Detailed Site Plan Penn Place II

DET-2024-020

STAFF REPORT

SUBJECT: Detailed Site Plan DET-2024-020
Type 2 Tree Conservation Plan TCP2-2025-0058
Penn Place II

1 SUBMERGED GRAVEL WETLAND DETAILED PLANTING PLAN
L-1.04

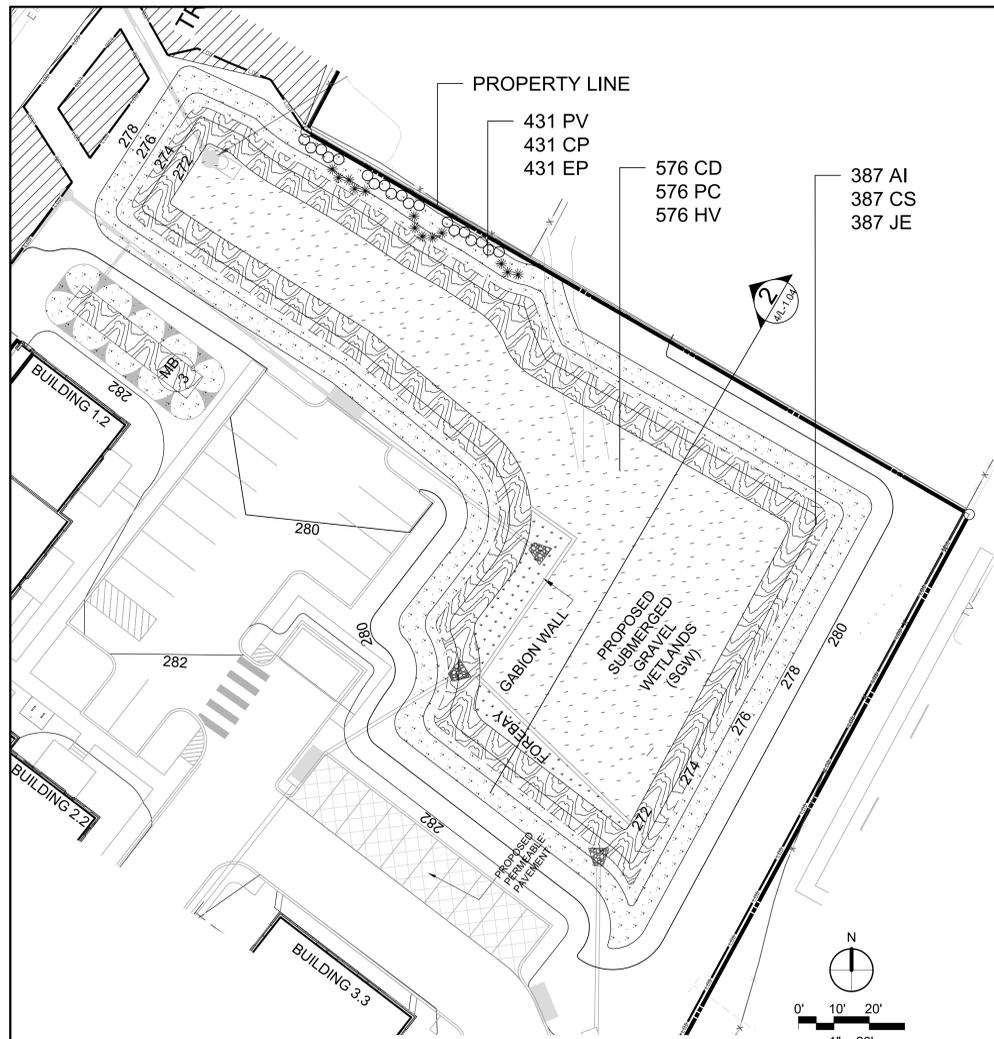
2. Prior to certification of the detailed site plan (DET), the landscape plans shall be revised as follows:
- a. Revise the submerged gravel wetland detailed planting plan on Sheet L-1.04 to match the submerged gravel wetlands as shown on the DET.
